## NZ NOTICES TO MARINERS EDITION 12 9 June 2006

NZ 131/06 SOUTH PACIFIC OCEAN – Soth East Polynesia – Iles Marquises – Depth.

Chart NZ 14607 (INT 607) [ 148/05 ]

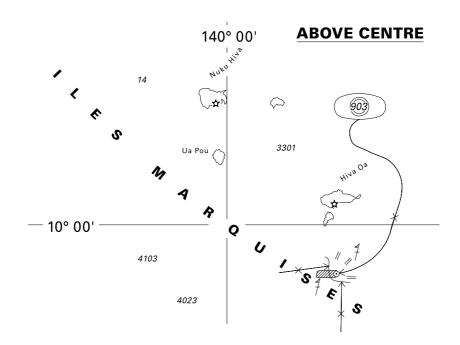
Insert depth 903 enclosed by 1000m and 2000m contours 10° 26'S., 139° 01'W.

extend 3000m contour SW to enclose

Delete depth 3060 10° 26'S., 139° 06'W.
